**COUNTY OF SAN MATEO
PLANNING AND BUILDING DEPARTMENT**

SUBJECT: EXECUTIVE SUMMARY: Consideration of a Resource Management District Permit, Grading Permit, Architectural Review Exemption, and certification of a Mitigated Negative Declaration, pursuant to the California Environmental Quality Act, to construct a new single-family residence, associated structures, and 3,381 cubic yards of grading. The project is located at 13040 Skyline Boulevard in the unincorporated North Skyline area of San Mateo County.

County File Number: PLN 2015-00236 (Parlette/Stern)

- DESIGN AND CONSTRUCTION SPECIFICATIONS FOR CONSTRUCTION ENTRANCE**
- JOHN C. BERRY
RCE 18720
EXP. 6-30-15
1. THE MATERIAL FOR CONSTRUCTION OF THE PAD SHALL BE 1-1/2 TO 3 INCH STONE.

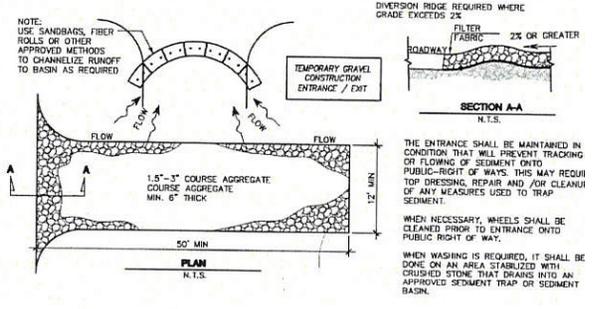
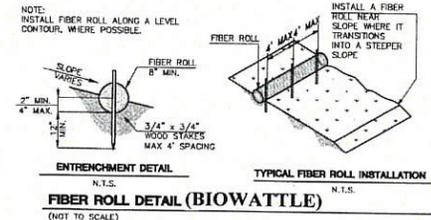
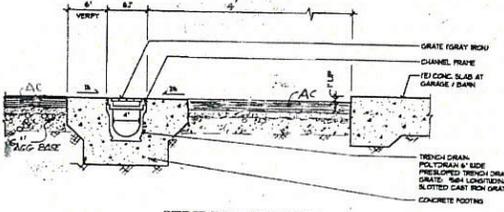
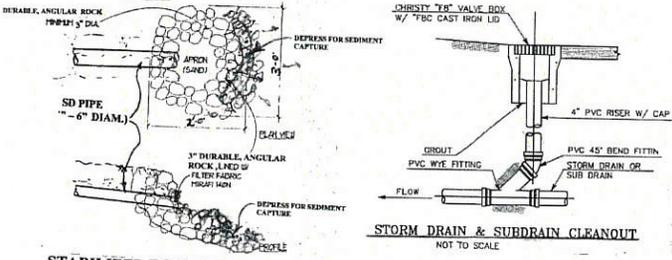
- a. Show the location(s) for storage of construction material, construction equipment, and parking of construction vehicles on the erosion control plan (Sheet C304), as described in Section III (Management Practices Employed to Minimize Contact of Construction Materials, Equipment, and Vehicles with Stormwater) of the Erosion Control Notes and Details plan sheet.

- b. Provide a detail for the proposed silt fencing and protection for stockpiled materials (such as anchored down plastic sheeting in dry weather), as described in Section IV (Construction Material Loading, Unloading, and Access Areas) of the Erosion Control Notes and Details plan (sheet C305).

- c. Show the location(s) of construction staging area(s) on the erosion control plan (Sheet C304), as described in Section IV (Construction Material Loading, Unloading, and Access Areas) of the Erosion Control Notes and Details plan sheet.

- d. Note on the tree protection detail of the Erosion Control Notes and Details plan (Sheet C305) that tree protection shall consist of orange plastic fencing at the driplines where feasible.

- e. Provide a detail for the proposed “Limit of Construction” barrier/fencing (such as orange plastic fencing, chain link fencing, or other barrier measure) on the Erosion Control Notes and Details plan (Sheet C305).

- f. Show the location(s) of any office trailer(s), storage sheds, and/or other temporary installations on the erosion control plan (as applicable). As necessary, show how these temporary structures will be accessed and protection for any access routes.
